Serial No.: 09/996,486 9 81862.P251

Amndt. dated June 20, 2005

REMARKS

FIG. 2 (PRIOR ART)

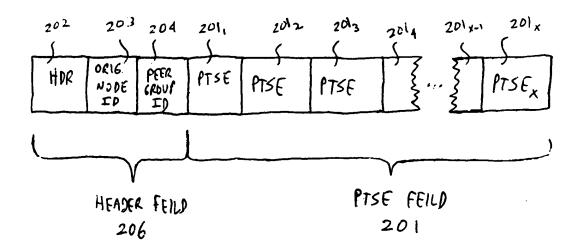
The Examiner has objected to the figures generally for "lack of legends" but has not elaborated on the deficiencies on the legends as filed (see, Examiner's Office Action mailed 2/18/05, pg. 2). The Applicant has included the legend "prior art" to Figures 2 and 3. The Applicant respectfully requests the Examiner to specify what additional legends are required.

Figures 2 and 3 have been amended so as to further include the legend "prior art".
